## THE CITY OF SAN DIEGO

Subject: Bacteria-1 and Chollas Creek Dissolved Metals TMDLs

### Storm Water Pollution Prevention Program

## Canyon Mouth Option

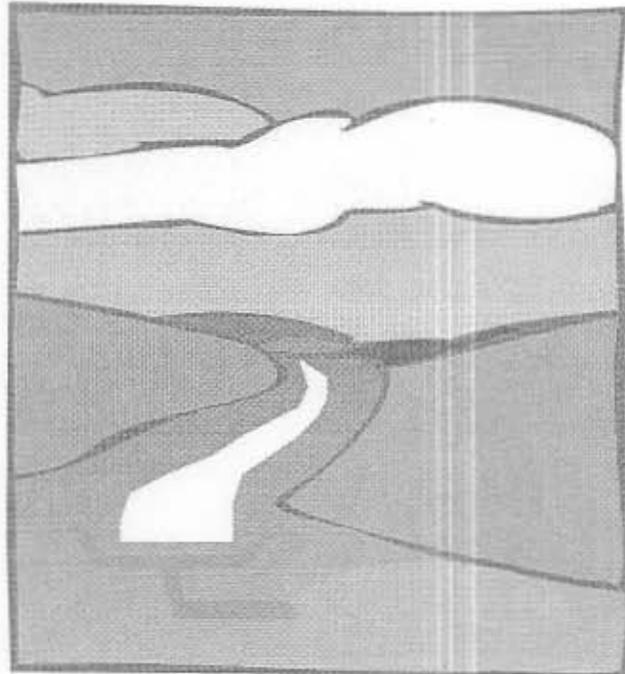
I have recently been invited by Regional Board staff to submit a proposal for what kind of BMP the City would like to build below outfalls. In response, I submitted the attached graphics and was told by Regional Board staff that these proposals were, in concept, acceptable, at least in terms of allowing receiving waters/Waters of the State to convey waste and in terms of achieving Wasteload Allocations below storm drain outfalls and still complying with the TMDLs. Please acknowledge that these solutions are conceptually acceptable. Based on a quick analysis, these solutions might be available for approximately 480 of the 800 outfalls within Chollas Creek.
